Sect 96 Amendment to Approved DA

Address
**13 Highview Avenue
Manly Vale NSW**

Project
**Alts and Adds to Existing
Residence**

Title
Elevations

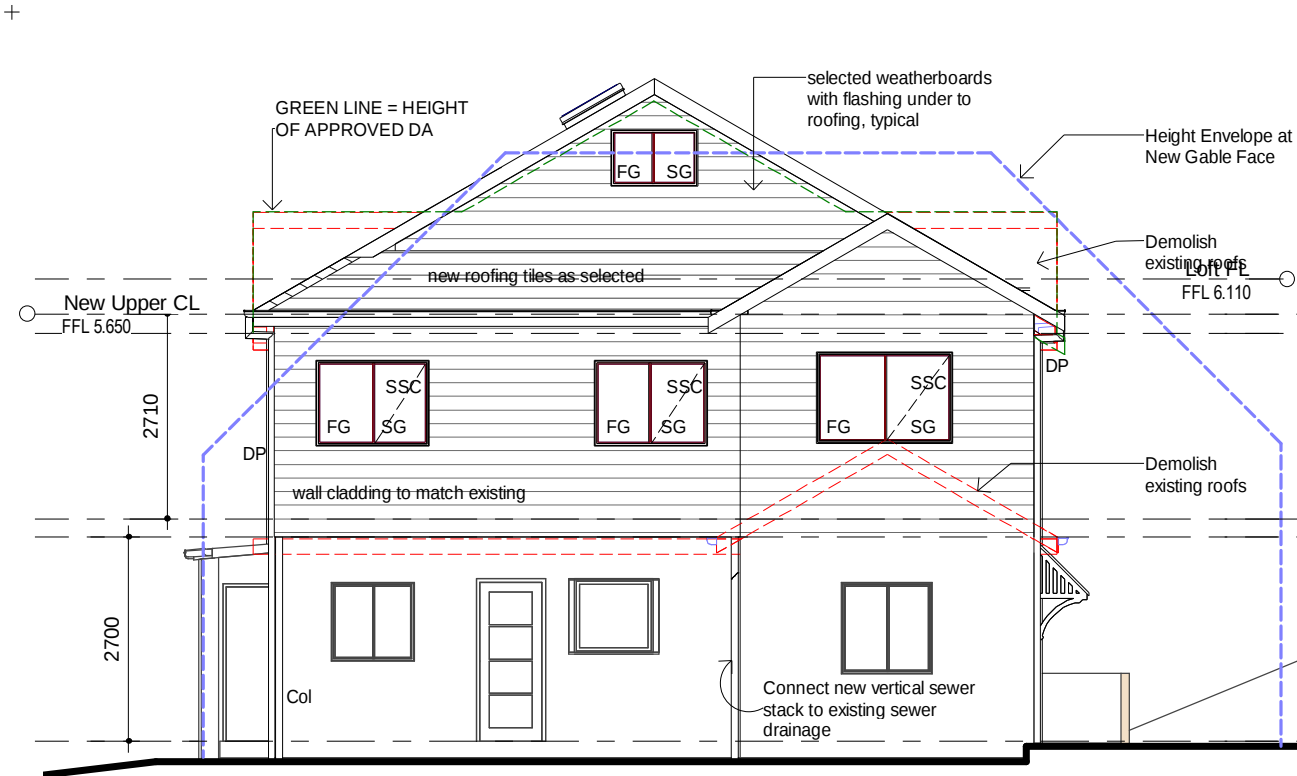
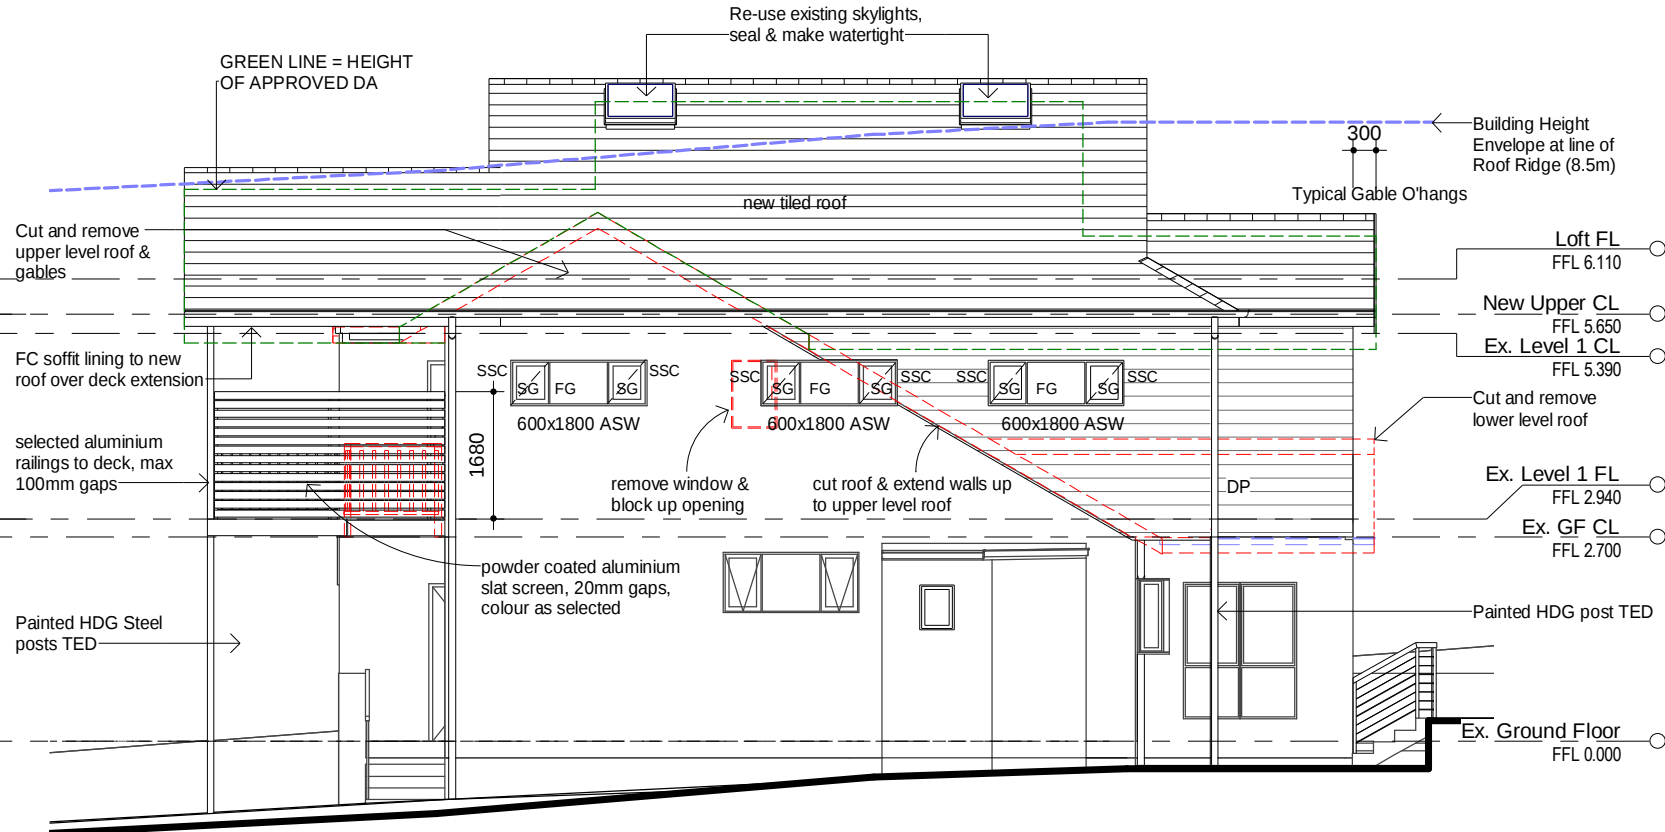
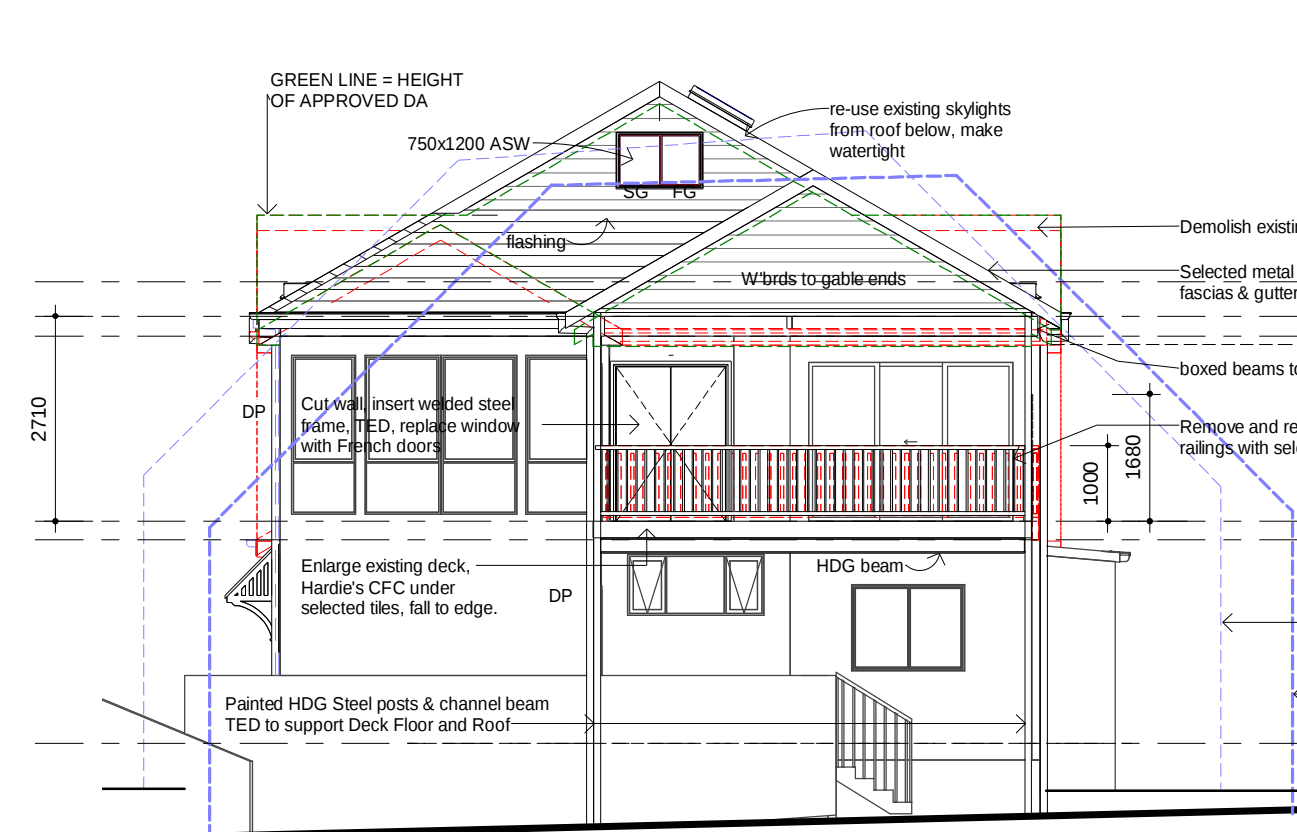
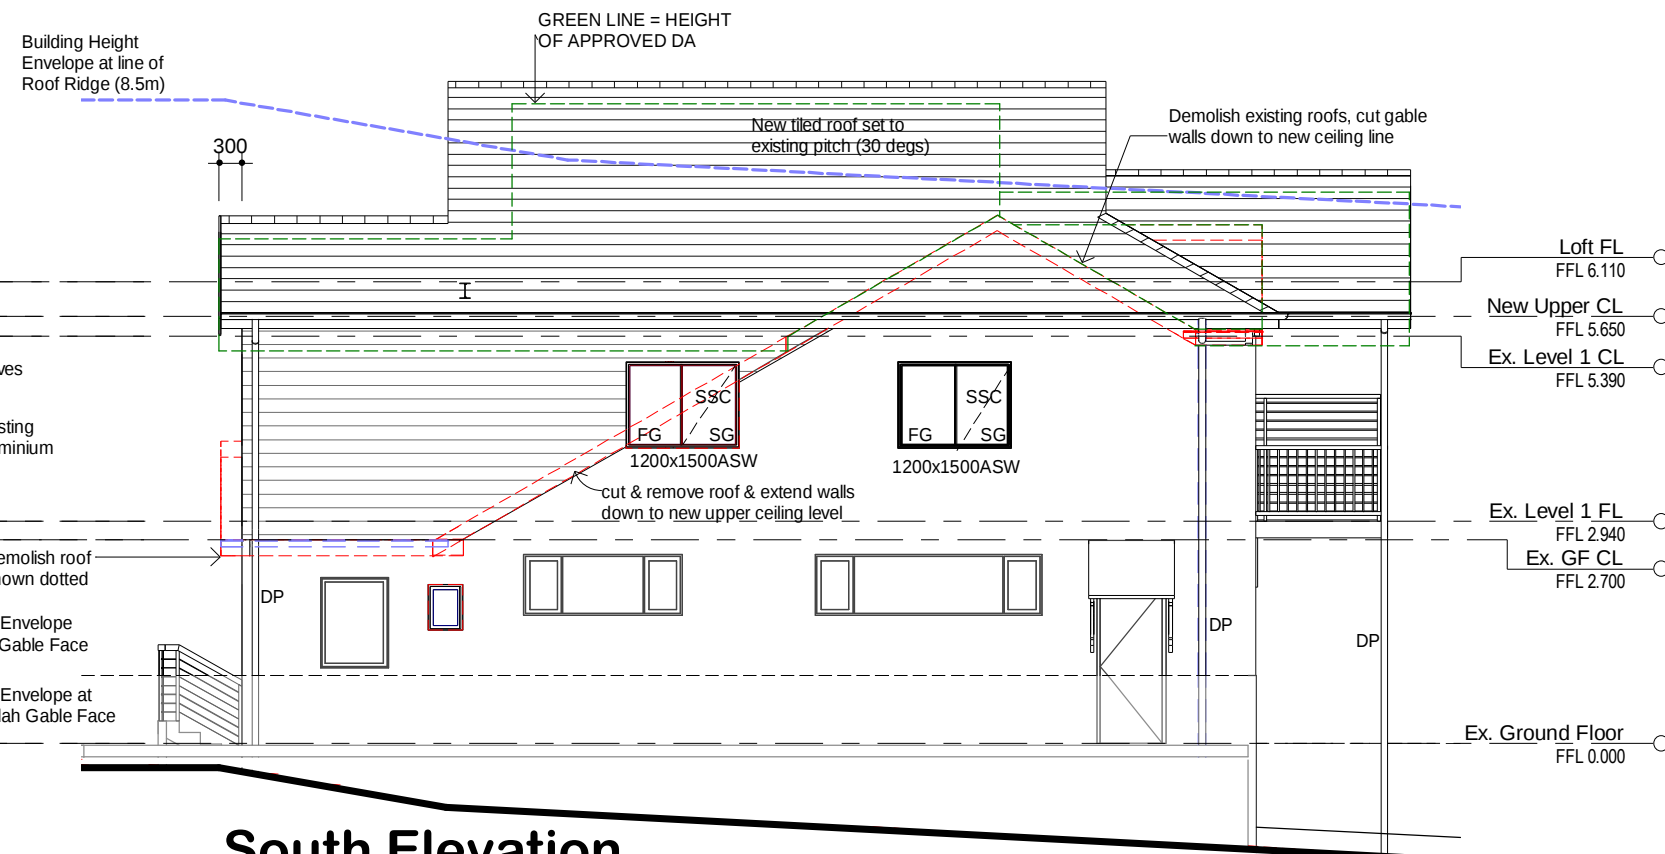
AMENDMENTS		
Issue	Description	Date
A	Issued for CC	Feb. 15
B	Deck size revised	Mar. 16
C	Upper Level Roof raised 300mm	Jan. '17
